**ആലപ്പുഴയിലെ സൂപ്പർ സ്പെഷ്യാലിറ്റി പഞ്ചകർമ്മ ഹോസ്പിറ്റൽ ആൻഡ് റിസർച്ച് സെന്റർ**

ENQUIRY REPORT

Sub:- Construction of Government Panchakarma Ayurveda Hospital building at Alappuzha by M/s Hindustan Prefab Ltd. - Enquiry Requested Reg.

Sub:- AYUSH-Construction of Government Panchakarma Hospital building at Alappuzha through M/s HPL - Substandard works - Retrofitting suggested - Reg.

##### **At portions where leakage were observed**

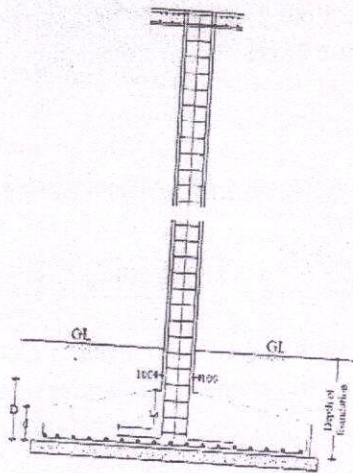
Adopt Pressure grouting technique using Epoxy resin injection chip off the plastered surface and apply micro concrete and apply rich mix of plaster.

##### **Eccentricity of Columns**

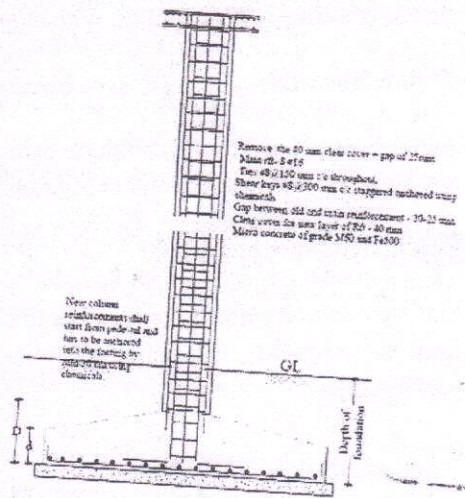
Since eccentricity are noticed in some columns at plinth and GF slab levels, RCC jacketing from the pedestal of footings till plinth beams and jacketing at GF portions have to be performed.

Column Retrofitting Sketches - Typical

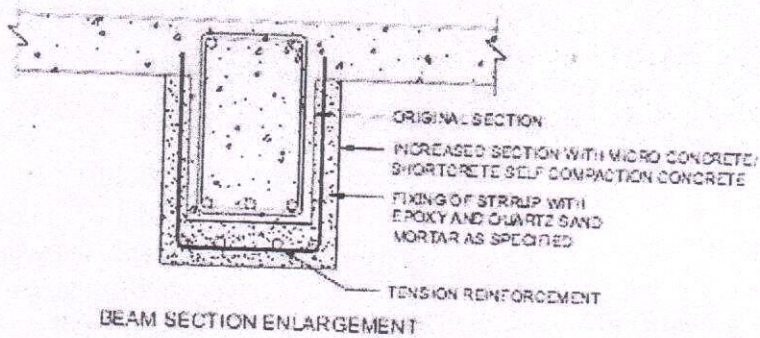
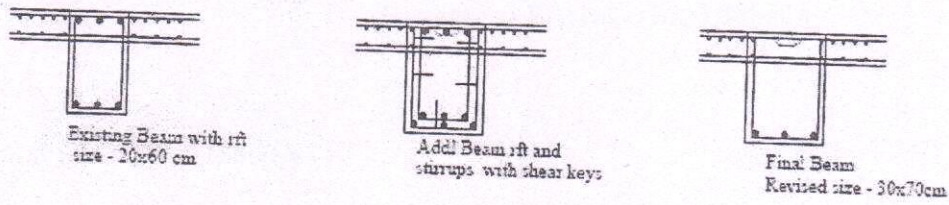
TYP. DETAILS OF RETROFITTED COLUMN

Existing Column rft  
Column size - 30x60  
cm

Addl Column rft and  
lateral ties with shear keys

Final column  
Revised size - 40x70cm

Remove the 40 mm clear cover + gap of 25mm  
Main rft. #16  
Ties #8 @ 150 mm c/c throughout.  
Shear keys #8 @ 300 mm c/c staggered anchored using chemicals  
Gap between old and main reinforcement - 20-25 mm  
Clear cover for new layer of Rft - 40 mm  
Micro concrete of grade M60 and Fe500
